**Town of Hilton Head Island
Regular Design Review Board Meeting
Tuesday, February 27, 2018 – 1:15 p.m.
Benjamin M. Racusin Council Chambers
AGENDA**

Chipotle / Starbucks
Shelter Cove Towne Centre
Hilton Head Island, SC

Design Review Board Site Resubmittal

Regarding: Pool Bar Jims

DATE: 2-13-2018
 PROJECT NUMBER: 01-17014
 SHEET TITLE: SITE PLAN

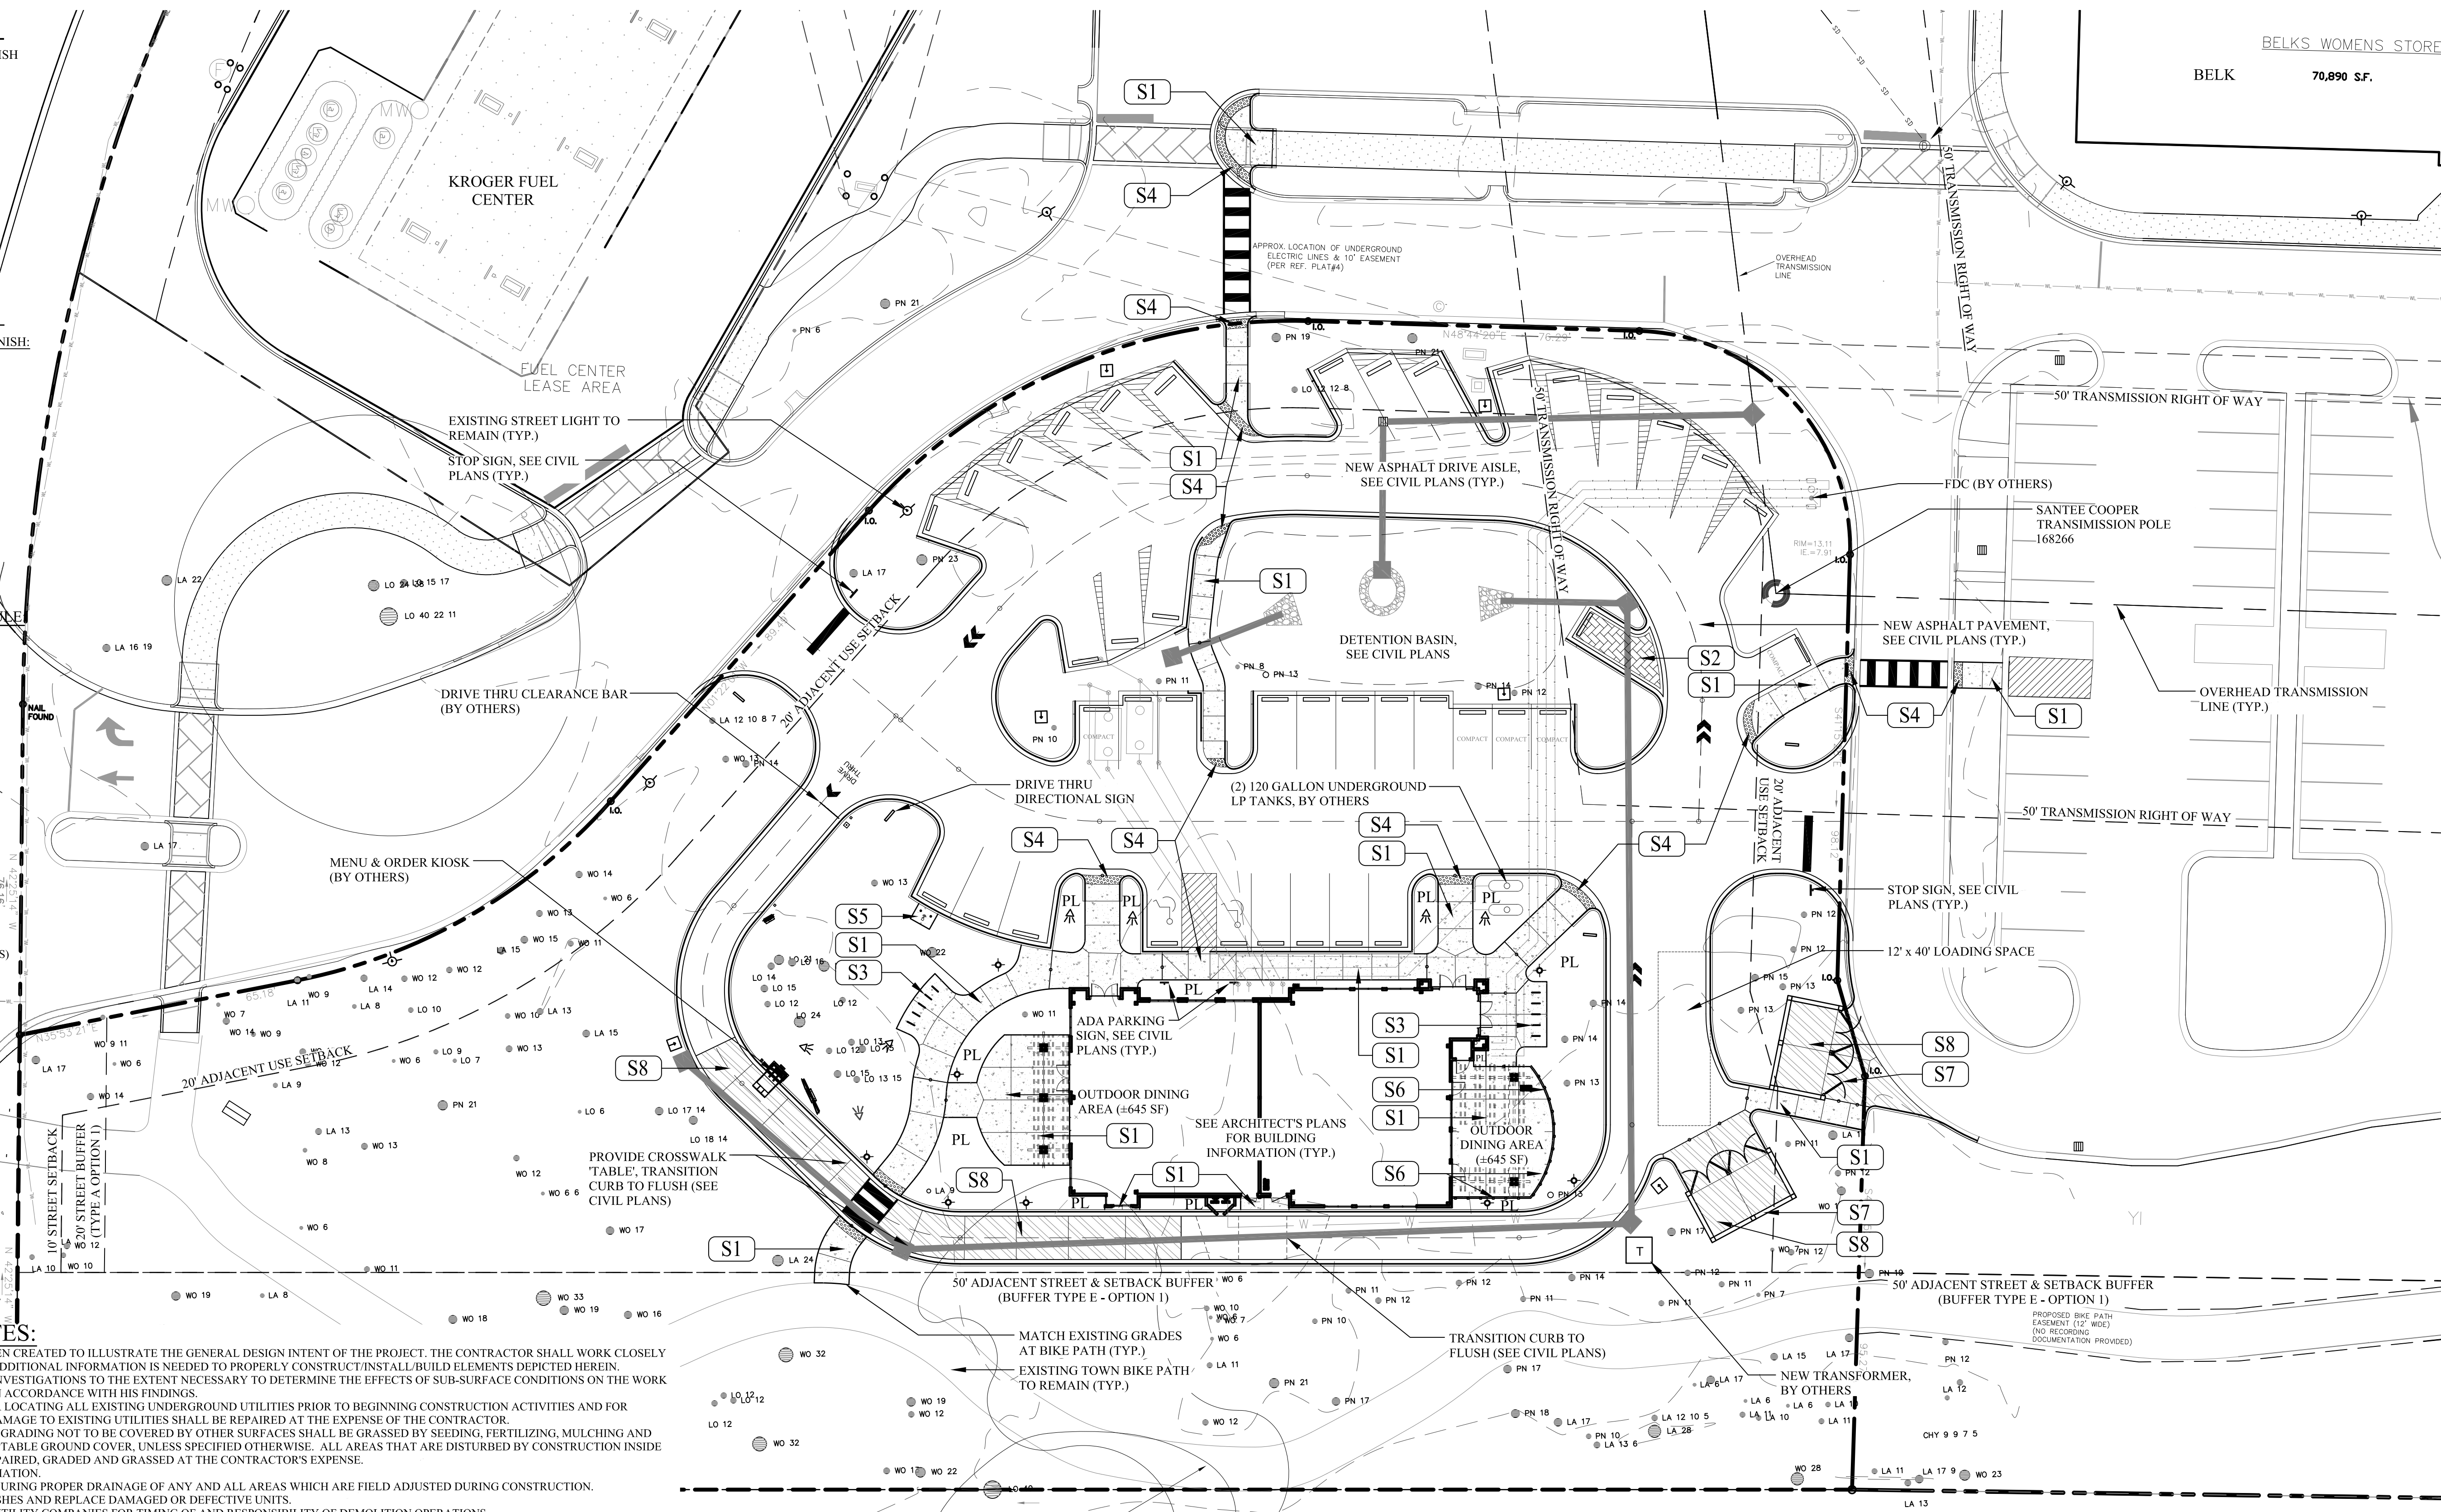
1. Replace 3 asphalt spaces at northwest property line with two compact paver spaces adjacent to 12", 12", & 8" multi trunked live oak and 21" pine.
2. Add canopy tree (live oak) to the northwest entrance, Hwy 278 side.
3. Replace 3 Crepe Myrtle in island opposite southwest entrance with canopy tree (live oak).
4. Unused asphalt beyond parking spaces shall not be stripped.

<i>MISC COMMENTS/QUESTIONS</i>
1. Add canopy tree (live oak) to the northwest entrance, Hwy 278 side.
2. Replace 3 Crepe Myrtle in island opposite southwest entrance with canopy tree (live oak).
3. Will the area between the parking spaces be striped as indicated on the Plans? What color?

CABANA ROOF PLAN $\frac{1}{4}'' = 1'-0''$

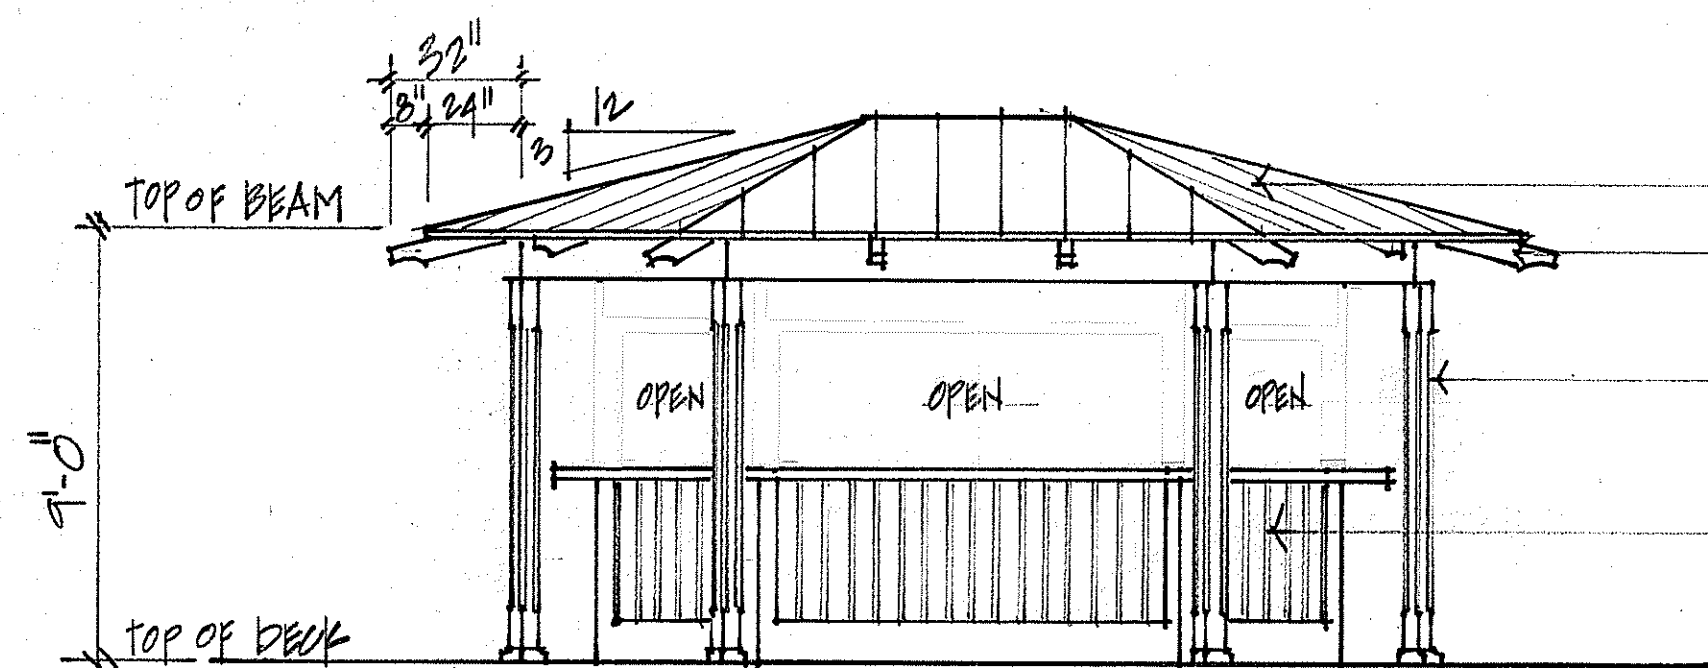
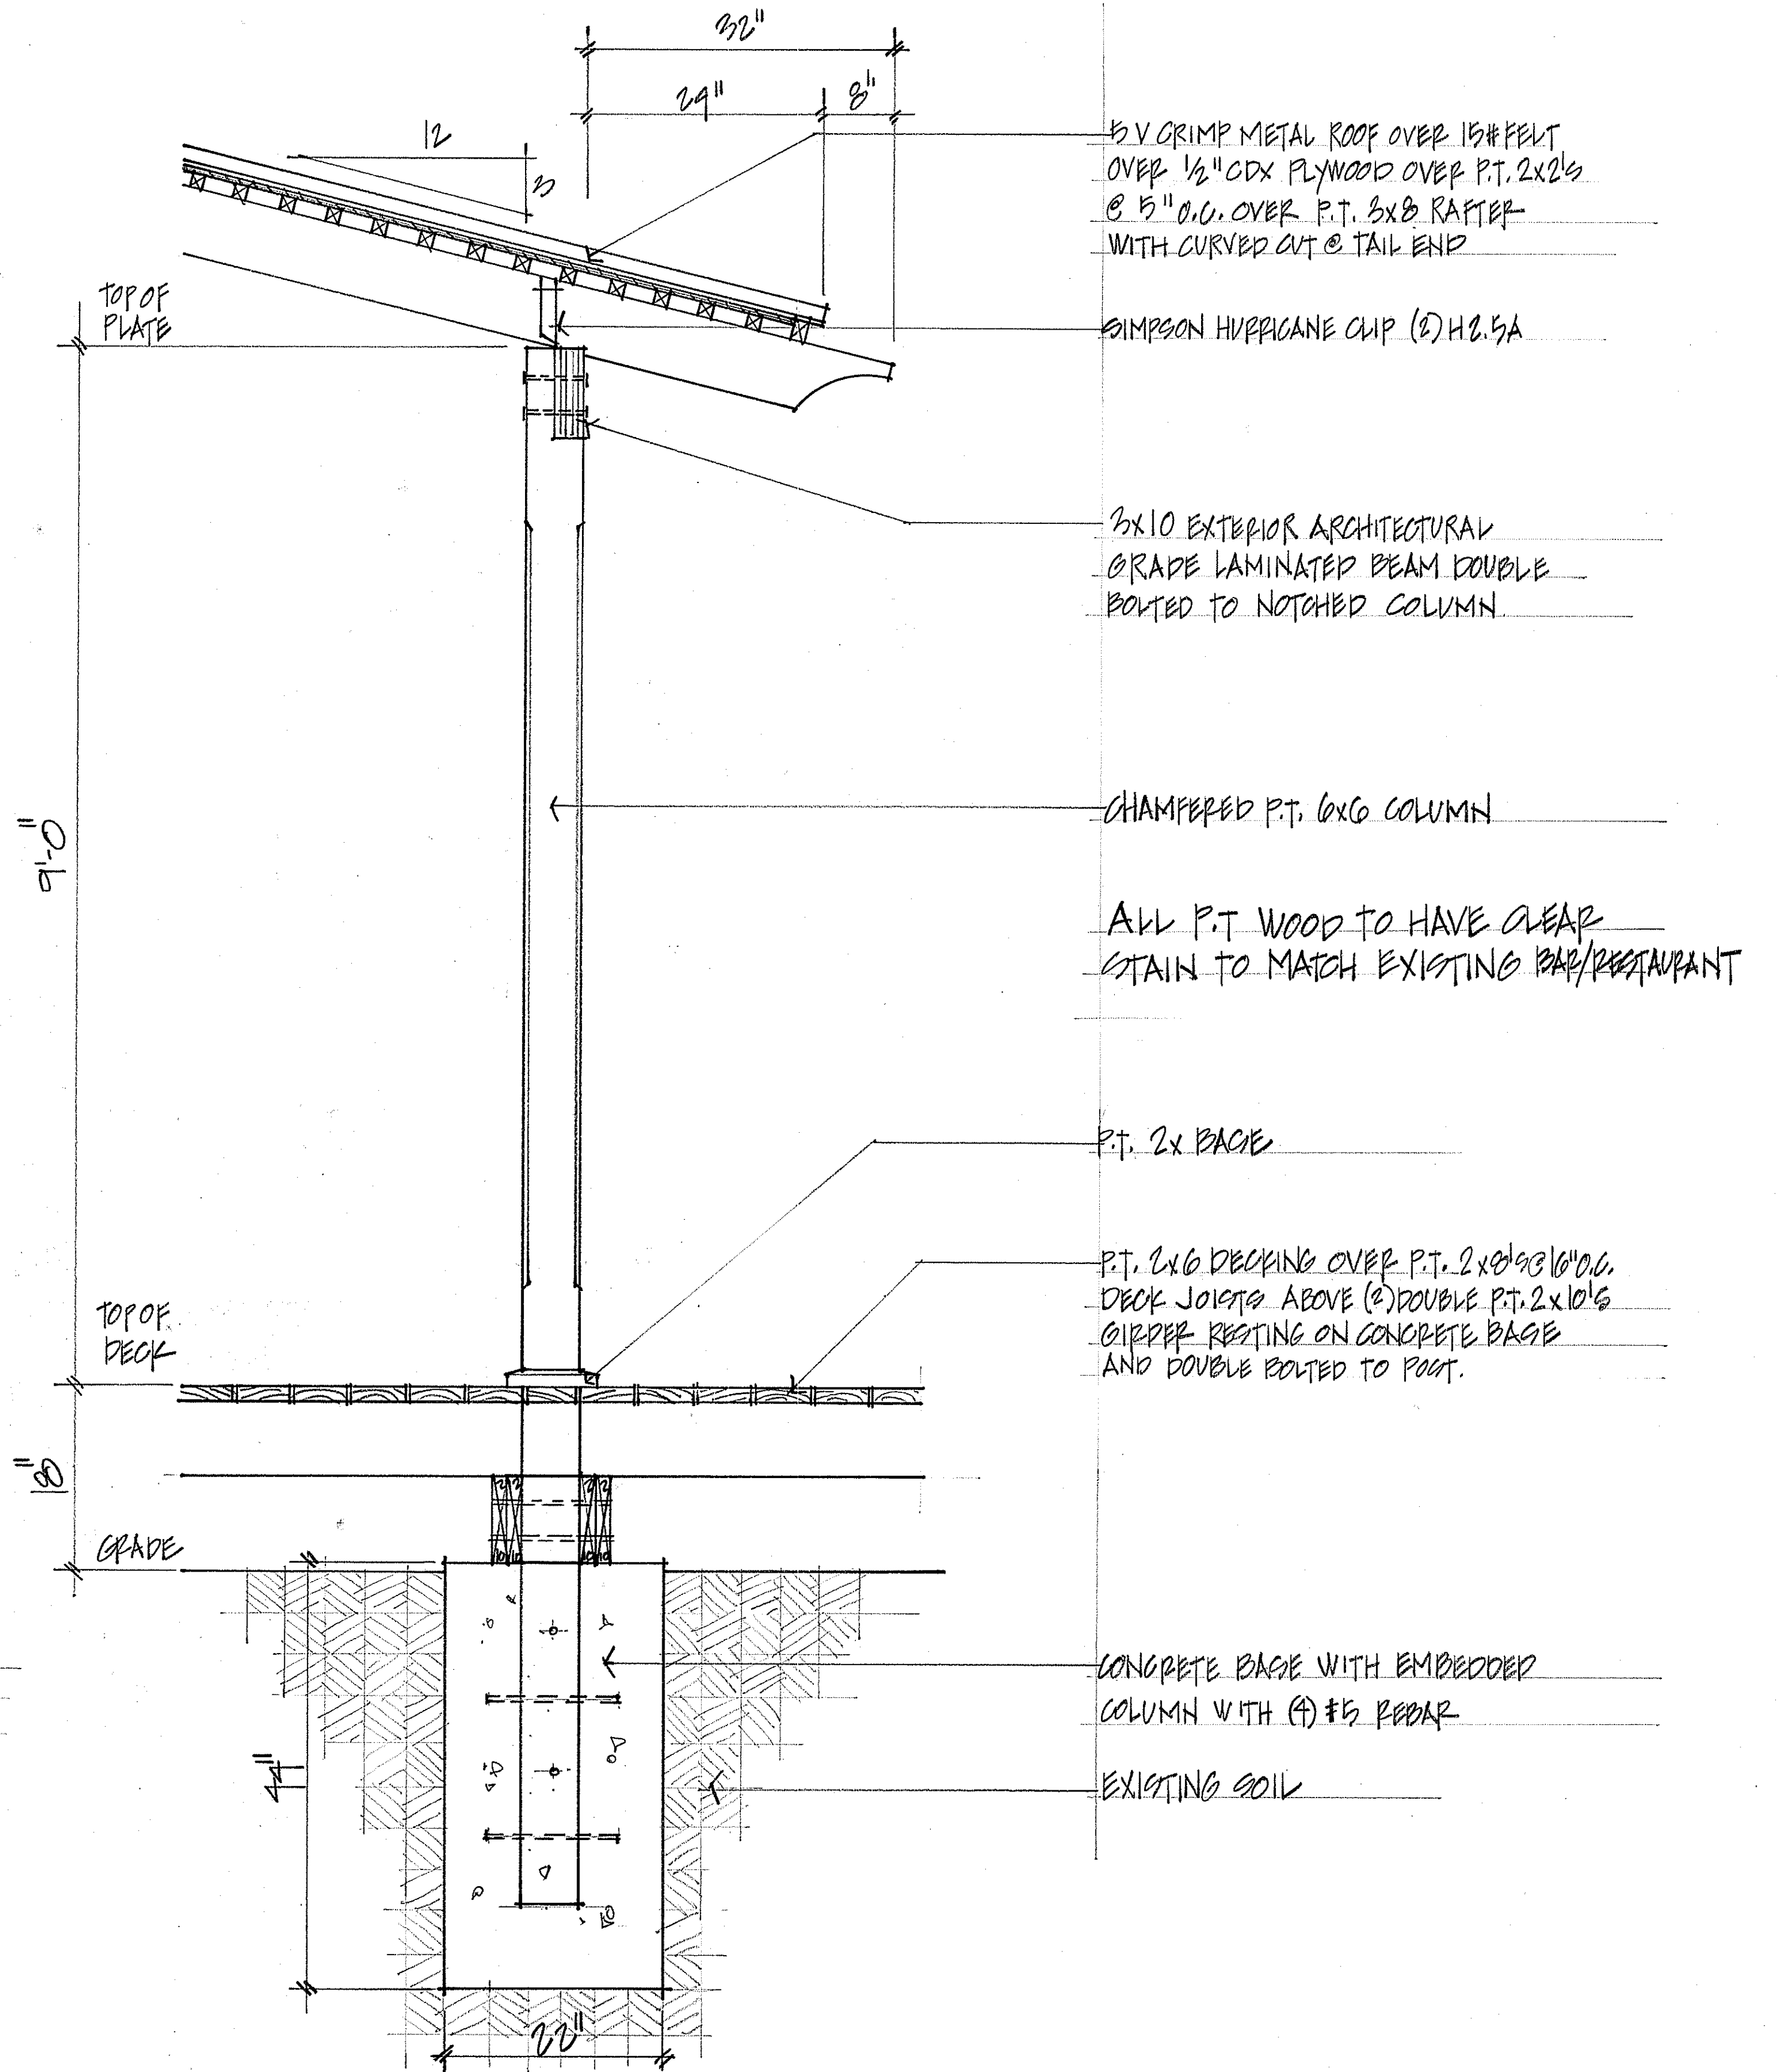
1. What do you mean by "Natural Color" you have specified. You need to specify a paint manufacturer and color or "to match" something on site.
2. The plans with the mobile bar are confusing. Will that roof be assembled under the permanent roof you are proposing? If so, I think that will be an uphill battle with the DRB. You need to note the plans or in your narrative what is happening with the roofs.

1. The roof color shall match the roof color of Sea Crest.
2. The proposed screen between the gazebo and the pool is not approved. In its place a railing to match the perimeter pool railing is approved.
3. Specify the color / finish of the removable bar for staff review and approval.
4. The new planter on the pool side of the gazebo shall be a minimum of 6' wide and extend the entire length of the gazebo deck addition. Provide a planting plan for this area to include a plant schedule for review and approval by Staff.
